NOTICE OF DATA INACCURACY

INSPECTION REPORT

Electrical Corporation:	Southern California Edison Company
Report Number:	PAD_SCE_LOK_20251007_1206
Date of Inspection:	October 7, 2025
City and/or County of Inspection:	Three Rivers, Tulare County
Inspector:	Lovepreet Kaur
WMP Year Inspected:	2025
Quarterly Data Report (QDR) Referenced:	Quarter 1 (Q1)
Inspection Selection:	Energy Safety viewed the contents of the Q1 QDR and performed an analysis that resulted in the selection of the WMP initiatives and locations referenced in this report.
Relevant WMP Initiative(s):	8.1.2.1.1 - Covered Conductor
Inspection Purpose:	Assess the accuracy of Southern California Edison Company's QDR data, completeness of its work, and performance of WMP requirements.

IA1Img3: Closer look at bare wire

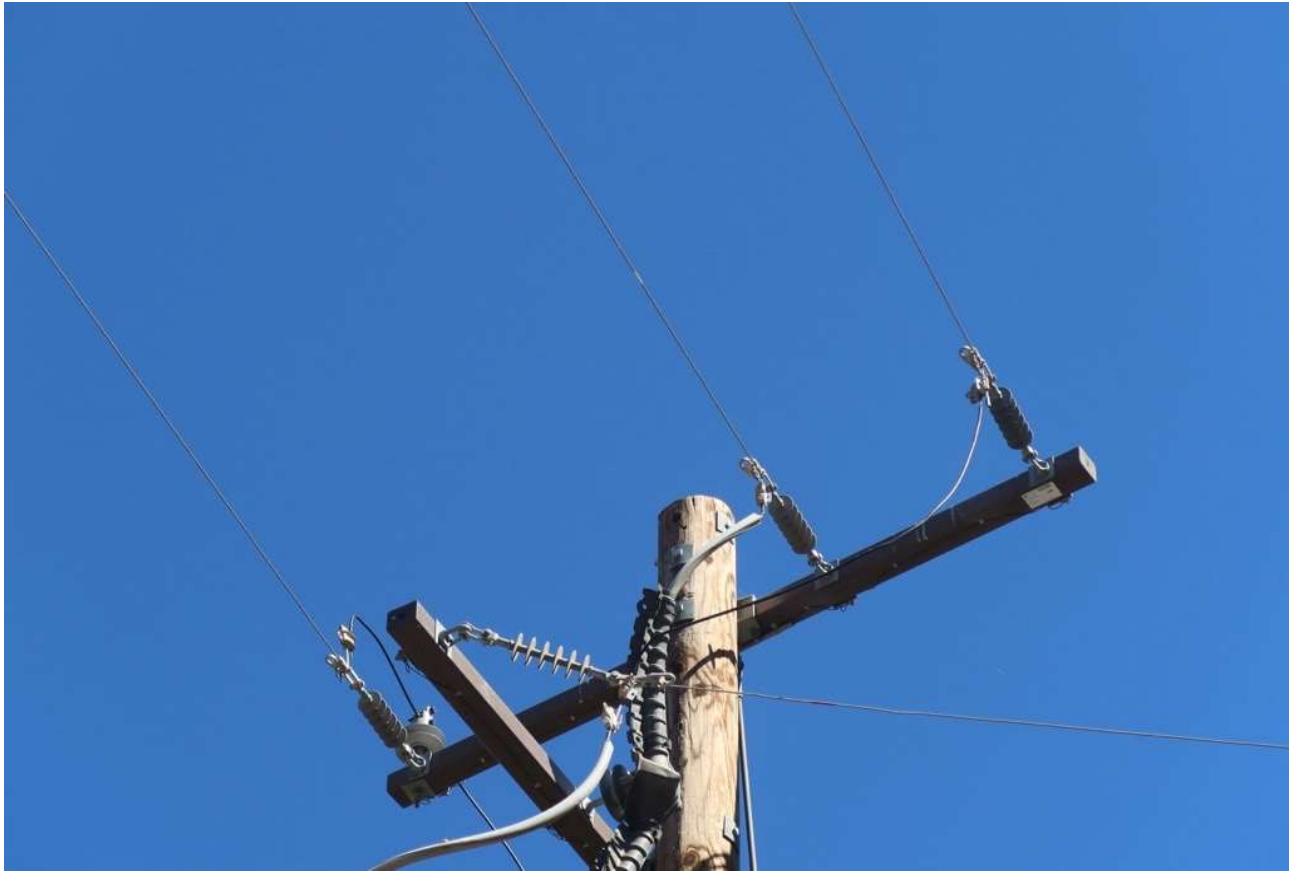
On Pole ID 4226445E, Grid Hardening ID TD2056799-4226445E at 45471 Sierra Dr, Three Rivers, CA 93271, USA, 36.4757551583404, -118.849816523769, the inspector observed that covered conductor was not installed. The inspector's observations are documented in Data Inaccuracy 1 photographs IA1Img1, IA1Img2, and IA1Img3 which are attached to this report as Exhibit A.

1. Southern California Edison Company reported in the Q1 QDR that WMP initiative 8.1.2.1.1 - Covered Conductor installation was completed at the inspection location.
2. Covered conductor was not installed; bare conductor was observed.

Within 30 days from the issuance date of this NODI, SCE should provide a response advising Energy Safety of corrective actions taken or planned to remedy the identified data inaccuracy or inaccuracies.
